**ITEM #5 - PRELIMINARY PLAT
SPRUCE PARK ESTATES SUBDIVISION DAVIS ADDITION NO. 2**

KPB File No.	2025-078
Plat Committee Meeting:	June 9, 2025
Applicant / Owner:	Ronald L. Davis Jr. and Shelley A. Davis of Soldotna, Alaska
Surveyor:	Jerry Johnson; Johnson Surveying
General Location:	Spruce Park Drive off Irish Hills Avenue, Kalifornsky Area

STAFF REPORT

Spruce Park Estates Subdivision Davis Addition No. 2 Preliminary plat

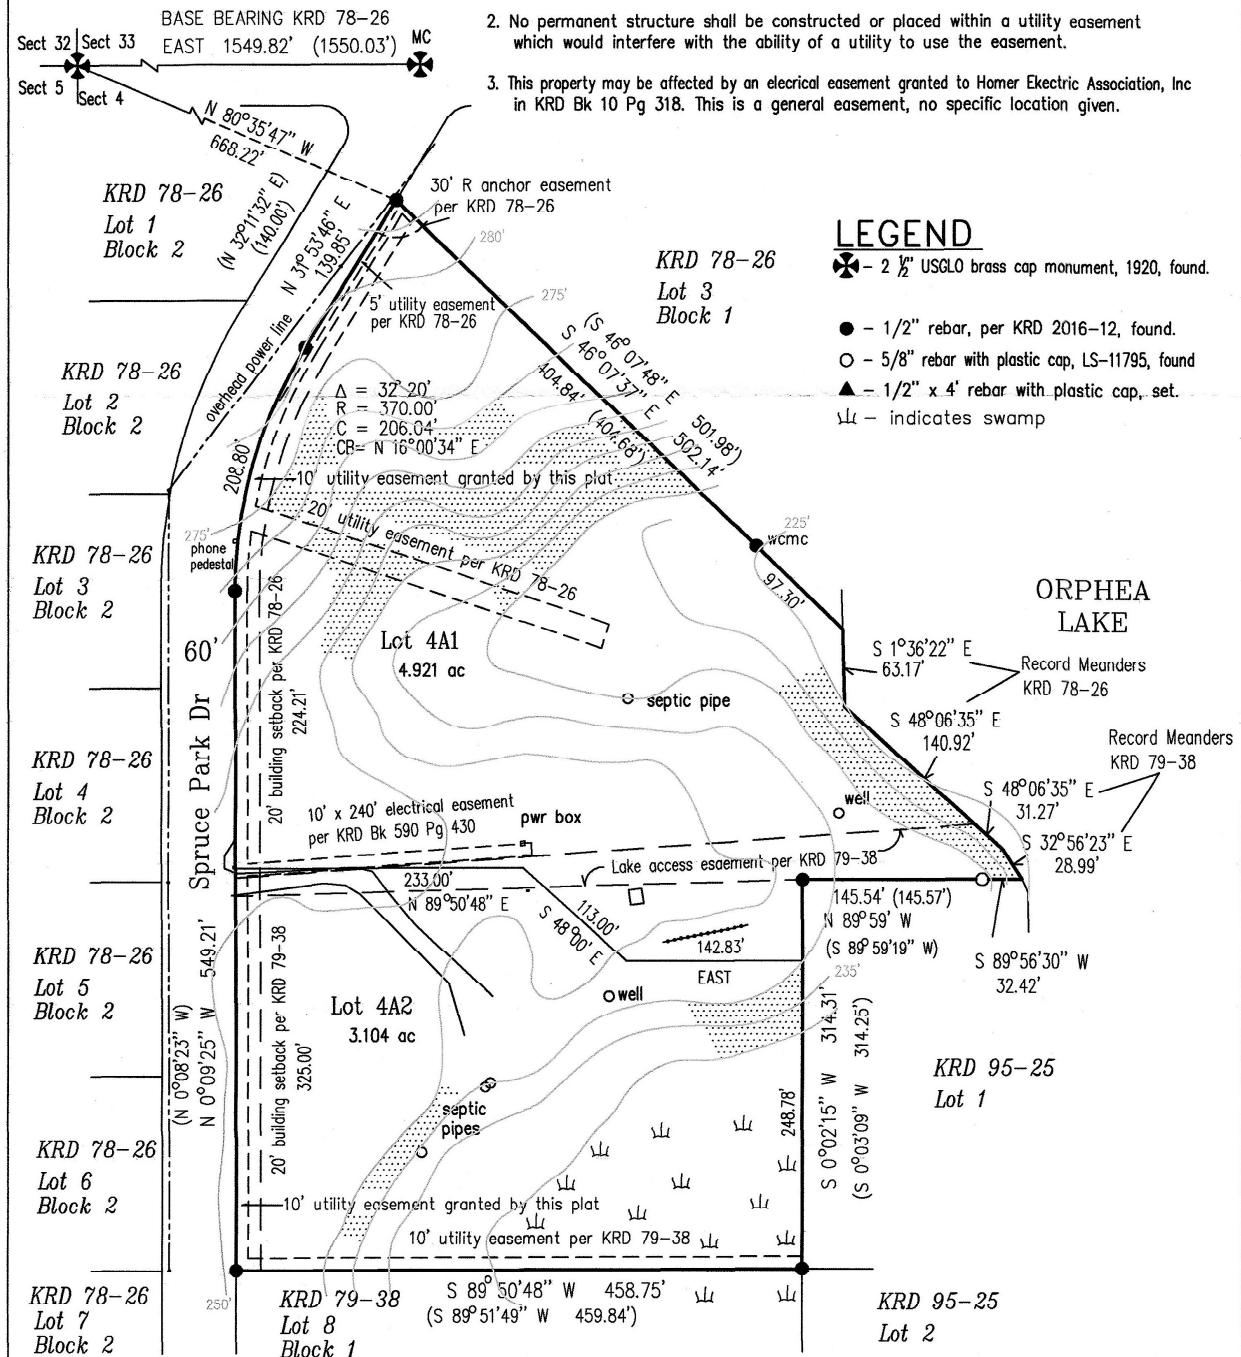
encroachment issues on the preliminary design when comparing the imagery to the preliminary plat. **Staff recommends** the surveyor confirm if there are any encroachments during the field survey and to notify staff of any encroachments with a resolution prior to finalization.

Orphea Lake abuts the subdivision on the eastern side of proposed Lot 4A1. KWF Wetlands Assessment shows wetlands on the southeast section of Proposed Lot 4A2 identified as Kettle. The preliminary plat contains a label for the lake and symbology representing swamp for the kettle. **Staff recommends** to include a note on the final plat indicating any person developing the property is responsible for obtaining all required local, state, and federal permits, including a U.S. Army Corps of Engineers wetland determination if applicable.

KPB GIS Terrain Viewer shows steep areas affecting the subject property. Contours have been added on the preliminary plat with grades over 25% shaded. **Staff recommends** the surveyor's to remove the contours from the final plat per KPB 20.60.010 and label the top and toe of slopes.

A soils report will be required and an engineer will sign the final plat as proposed Lot 4A2 is less than 200,000 sq ft (135,210.24 sq ft). **Staff recommends** the surveyor add the proper wastewater disposal note and reference to the corresponding lot to the final plat.

A soils report will not be required for proposed Lot 4A1 as the lot is greater than 200,000 sq ft (214,358.76 sq ft). **Staff recommends** the surveyor include the corresponding lot to the proper wastewater disposal note.

A general easement for electric lines or system and/or telephone lines was granted to Homer Electric Association, Inc. as recorded in Miscellaneous Book 10, Page 318, KRD. This easement is denoted as plat note number 3. **Staff recommends** correcting the typos within the plat note.

A 10-foot by 240-foot electrical easement was granted to Homer Electric Association, Inc. as recorded in Book 590, Page 430, KRD. This easement has been correctly depicted on the plat. **Staff recommends** the surveyor include a plat note referencing the easement.

Show set pins on new lot line

Add distances where missing for new lot lines.

- **Staff Suggests for the plat name:** Spruce Park Estates Subdivision Davis Replat Addition No. 2
- Modifications to the legal description:
 - Located in the NW 1/4
 - Township 3 North
 - Modify Kasilof to Kalifornsky
- Modify the KPB File Number to 2025-078
- Name of the Owners:
 - Ronald Davis Jr. AKA Ronald L. Davis Jr.
 - Revise name to: Shelley Davis AKA Shelley A. Davis

Label Shoreline Ave and ROW to the north

- Add a label for Reflection Lake
 - Modify spelling of Orpheia Lake
- G. The status of adjacent lands within 100 feet of the proposed subdivision boundary or the land status across from any dedicated rights-of-way that adjoin the propose subdivision boundary, including names of subdivisions, lot lines, block numbers, lot numbers, rights-of-way; or an indication that the adjacent land is not subdivided;
Staff recommendation:

- Add a label for the unsubdivided parcel to the northwest
- J. Block and lot numbering per KPB 20.60.140, approximate dimensions and total numbers of proposed lots;
Staff recommendation:

- Include "Block 1" on the proposed Lots
